Re: Buffalo Ridge Wind, LLC – Certificate of Need Application Amendment

MPUC Docket No. IP-IP7006/CN-19-309
OAH 82-2500-36550

Buffalo Ridge Wind Energy Center Turbine Layout Comparison

Figure 1. Project Layout

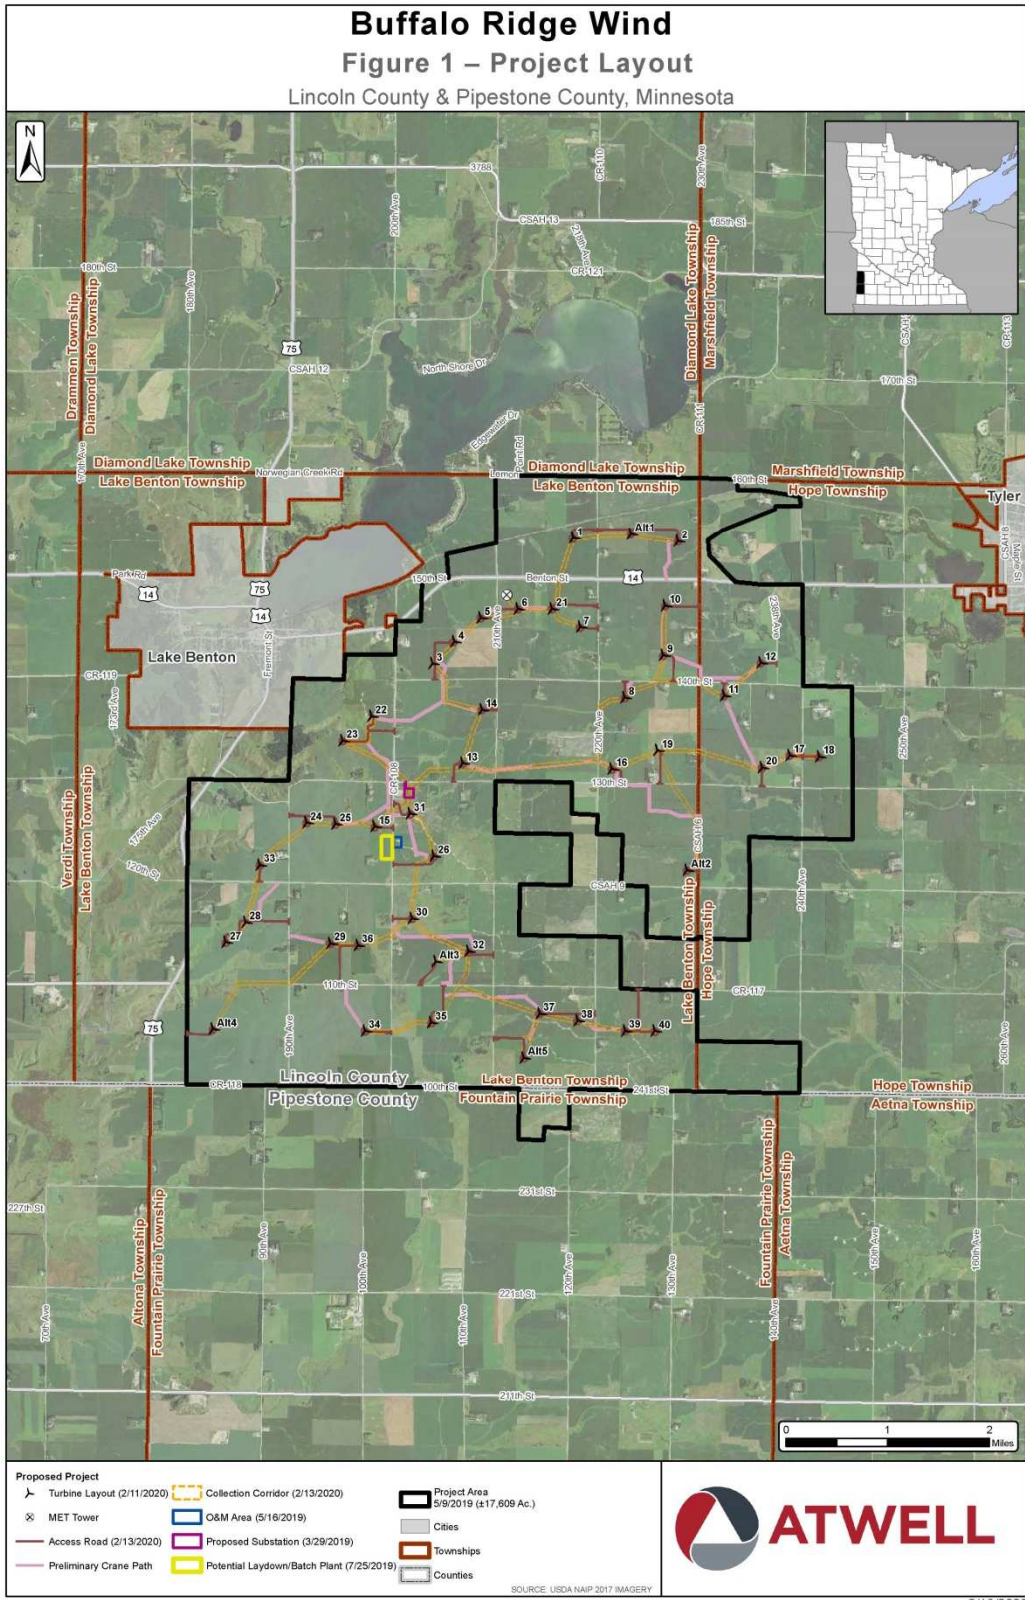
A map comparing the previous and revised wind turbine arrays is provided in **Attachment A**. Access roads, collection routes, and crane walks were adjusted to accommodate the revised turbine array and mapping is provided in **Figure 1**. **Table 1** provides a summary of the wind turbine design changes.²

The initial Application stated that three turbine models would be used for the Project, including: 31 GE 2.82 MW wind turbines, five GE 2.52 MW wind turbines, and four 2.3 MW wind turbines. However, the five GE 2.52 MW wind turbines are being replaced with GE 2.82 MW wind turbines for a total of 36 GE 2.82 MW wind turbines and four GE 2.3 MW wind turbines. The GE 2.52 MW turbines had a 127 m rotor diameter (RD) with 89 m towers. As both the GE 2.52 MW turbines and the GE 2.82 MW turbines have the same RD and hub height, this change is negligible. A map showing the updated Project is provided below in **Figure 1**.

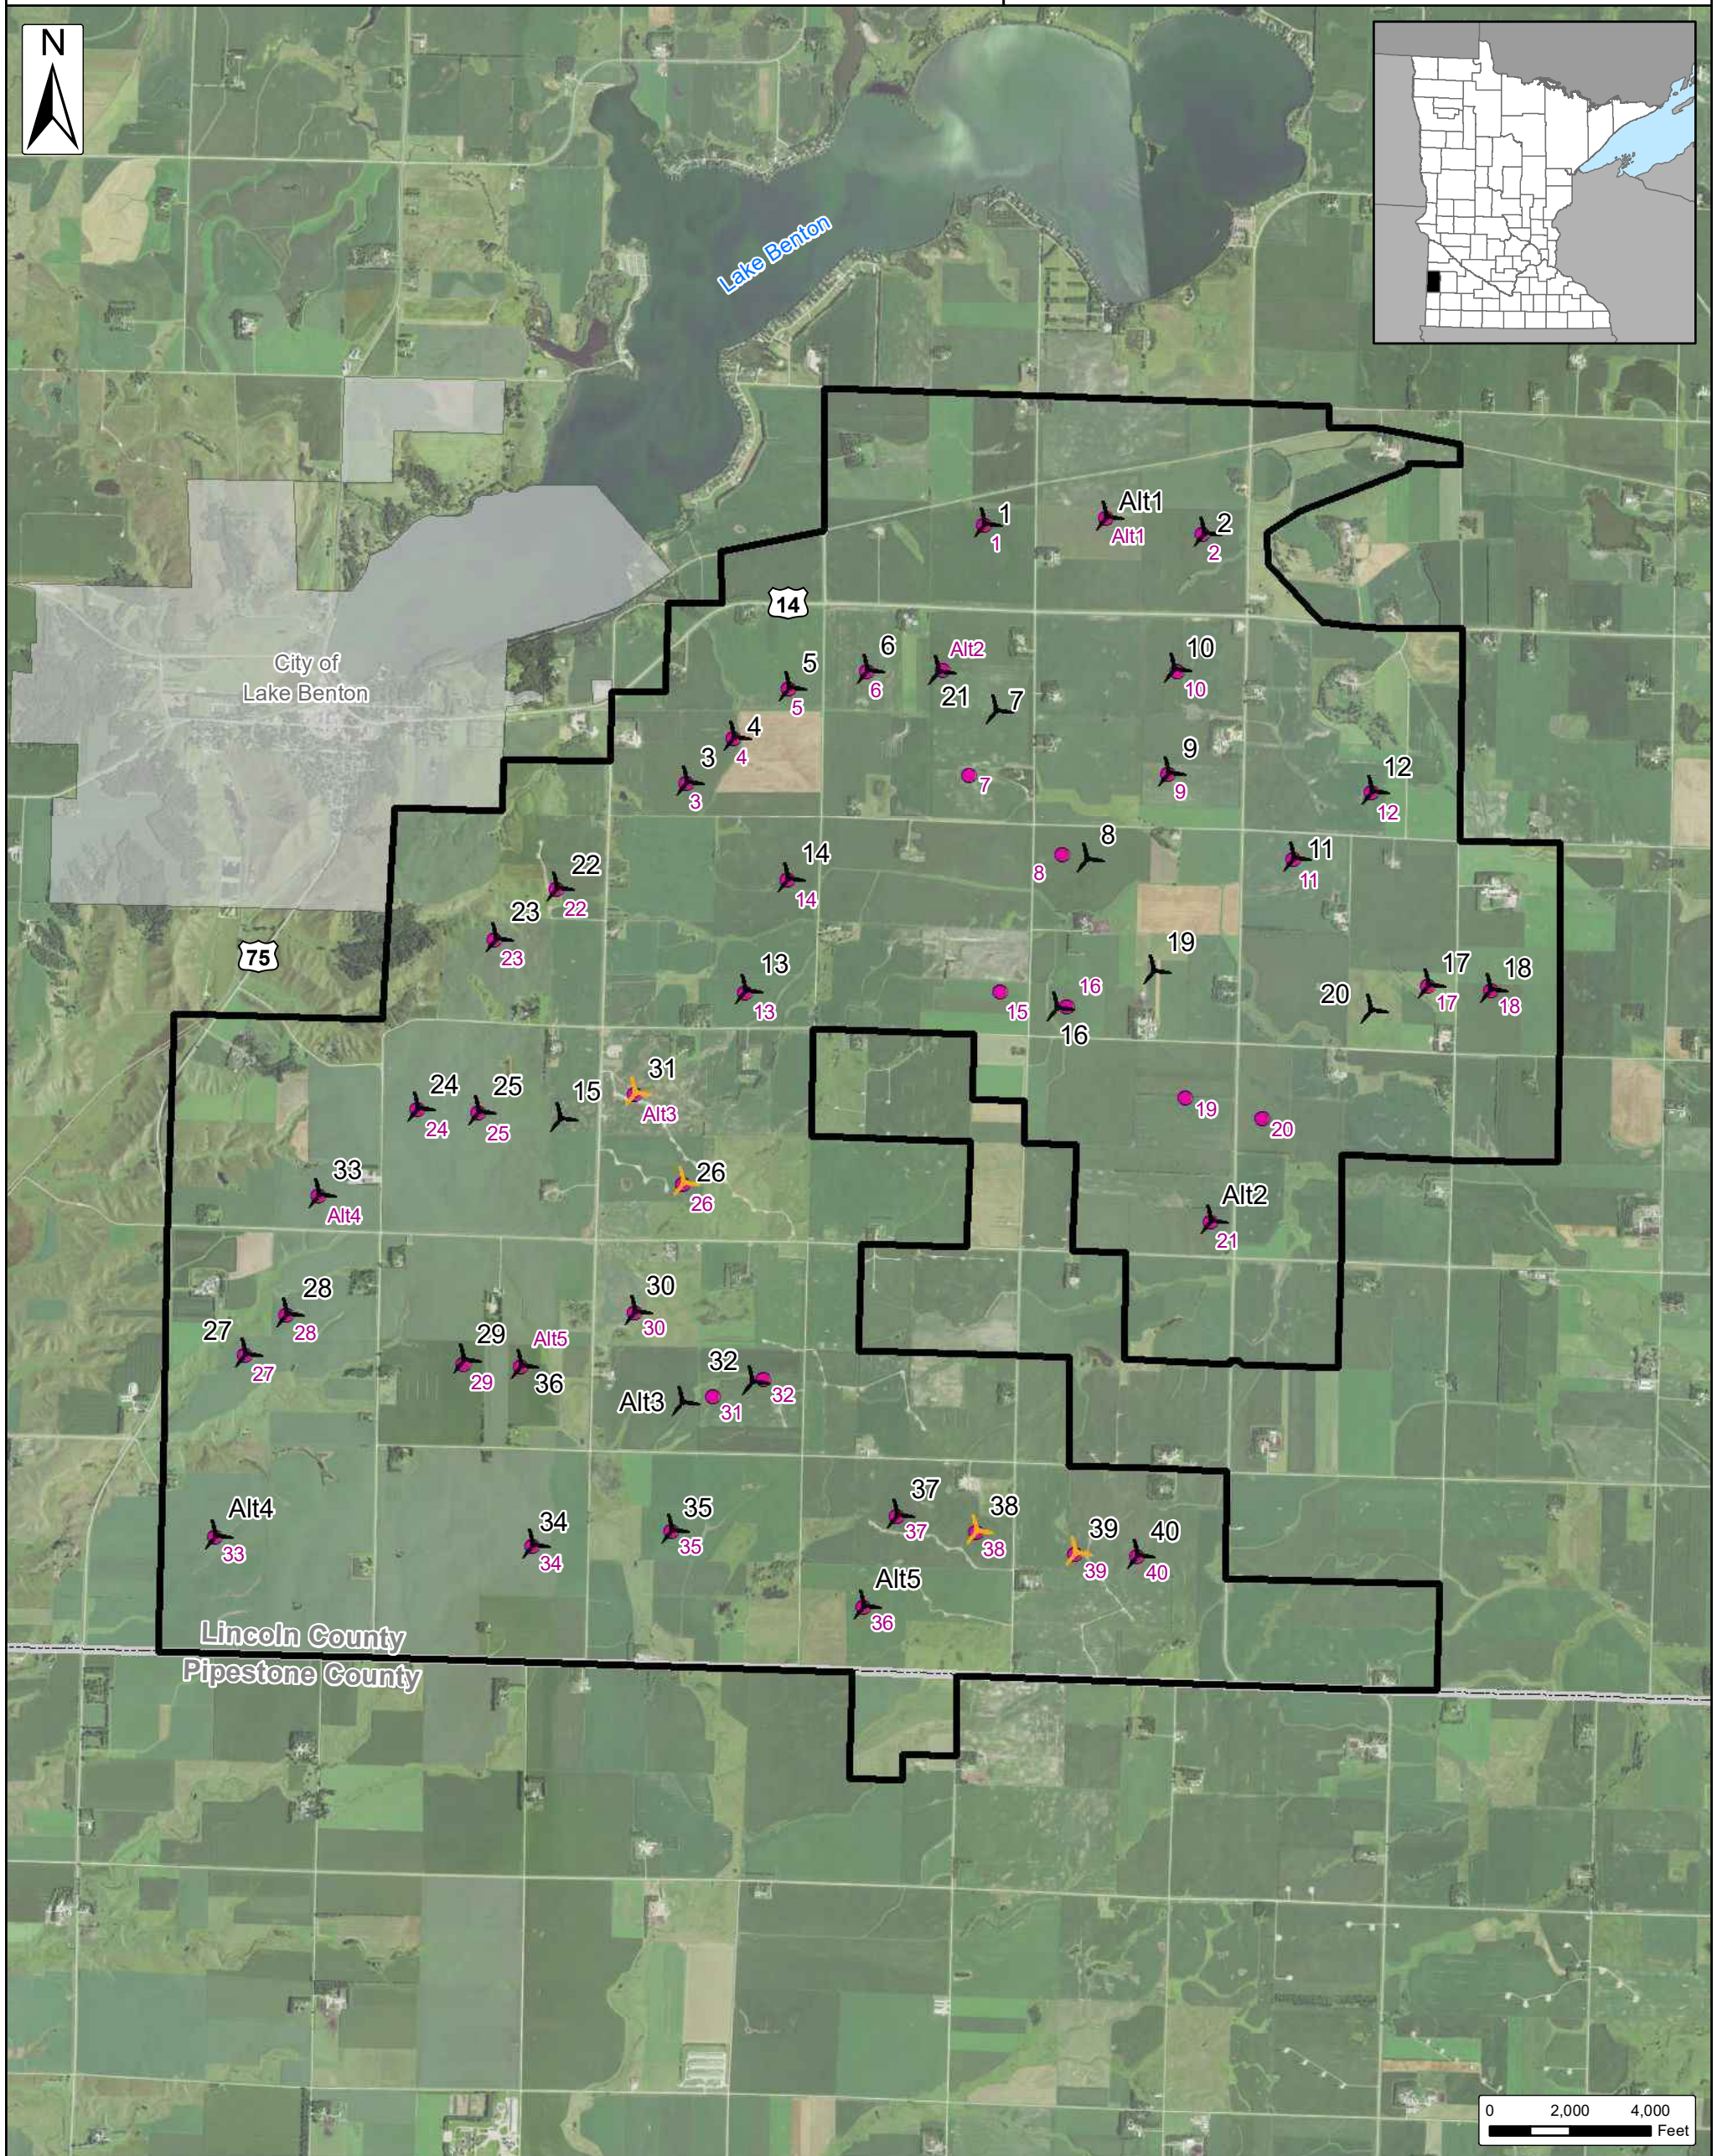
Buffalo Ridge Wind, LLC (BRW or Applicant) submits this Amendment to update its August 9, 2019 Certificate of Need Application (Application), related to the Buffalo Ridge Wind Project (Project), filed in Docket No. IP70061/CN-19-304. Specifically, since submittal of the Application, BRW has modified the wind turbine technology and layout within the original 17,609-acre Project Area to address a Federal Aviation Administration (FAA), Department of Defense (DoD), and U.S. Air Force (USAF) concern that the originally proposed wind turbine array may impact a common air route surveillance radar (CARSR). BRW has consulted with the FAA, DoD, and the USAF in revising the array to mitigate those agencies' concerns with respect to the impact on CARSR.¹

More specifically, the August 9, 2019 Application proposed 40 primary turbines using 31 General Electric (GE) 2.82 megawatt (MW) wind turbines, five GE 2.52 MW wind turbines, and four GE 2.3 MW wind turbines. Additionally, the initial layout proposed five alternative wind turbine locations including one GE 2.82 MW wind turbine, three alternative GE 2.52 MW wind turbines,

and one GE 2.3 MW wind turbine, for a total of 45 turbine locations. The modified design uses 36 GE 2.82 MW wind turbines and four GE 2.3 MW wind turbines. The updated wind array also includes five alternative GE 2.82 MW wind turbine locations for a total of 45 wind turbine locations. Due to changes in turbine technology, the Project’s total power capacity will decrease slightly from 109 MW to 108.7 MW.
